**REVIEW OF AIR QUALITY IMPACT ASSESSMENTS  
GLEBE ISLAND PORT  
CONCRETE BATCHING PLANT &  
GLEBE ISLAND MULTI-USER FACILITY  
GLEBE ISLAND NSW**

**Prepared for:** EDO NSW on behalf of Jacksons Landing Coalition

**Report No:** NICS\_182501\_AQIARReview\_REV02.docx

**Report Date:** August 2018

Figure B2: Site Location in the Regional Context

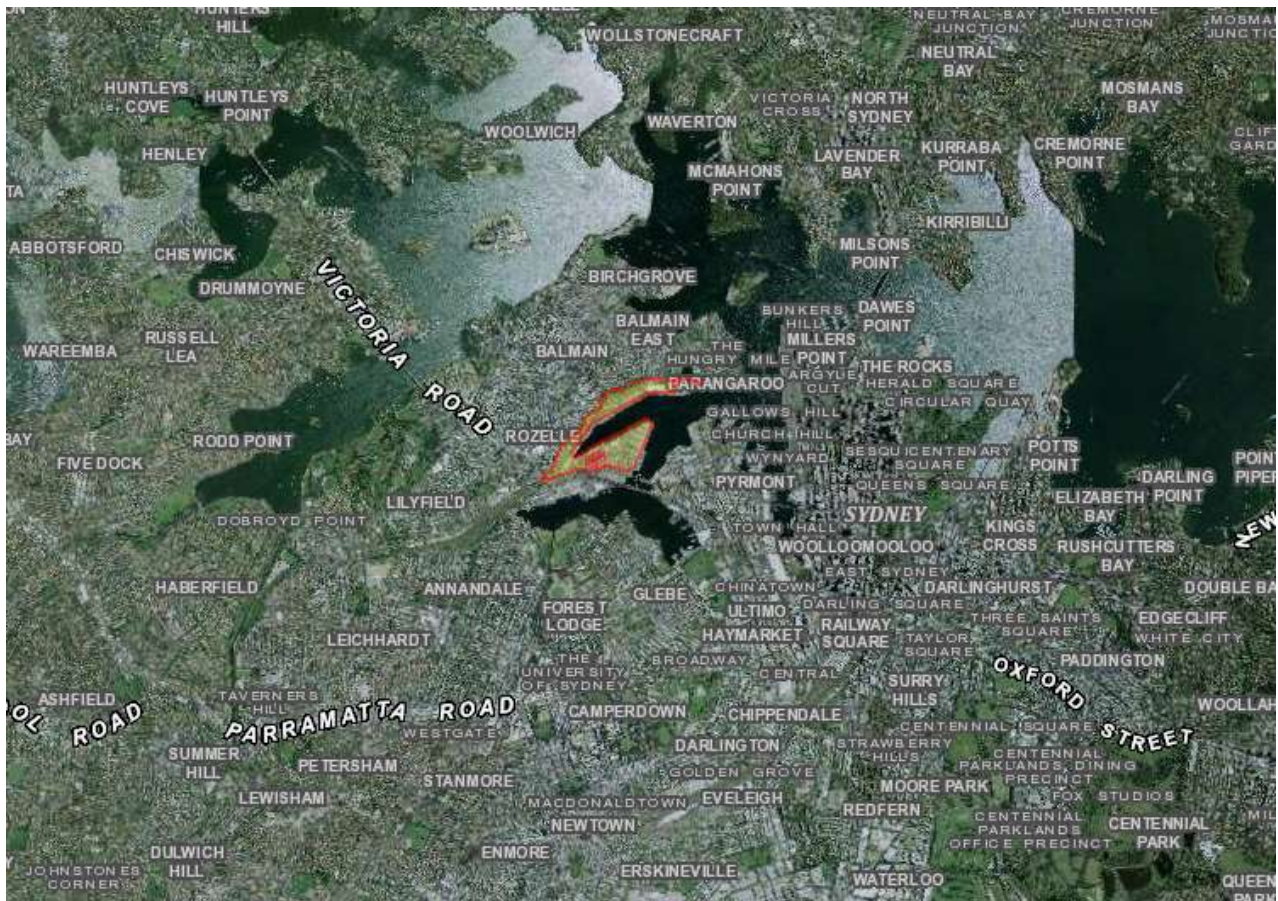
To give the reader a better understanding of the location of the site, it was considered appropriate to include **Figure B1** which shows the site in the local context and **Figure B2** which shows the site in the regional context. **Figure B3** shows the potentially sensitive receptors, as defined in the EPA's approved methods, in relation to the proposed location of the concrete batching plant since the AECOM AQIA did not identify any potentially sensitive receptors for the Multi-User Facility (Courtesy of Pacific Environment AQIA report). **Figure B4** shows the proposed site layout for the Multi-User Facility (Courtesy of AECOM AQIA report). It should be noted that the figures included in the AQIA prepared by AECOM did not include the North direction as required to ensure that a

clear comparison could be undertaken and the locations of sensitive receptors relative to the proposed site could be clearly shown. The figures appeared to be turned clockwise by approximately 65 degrees.
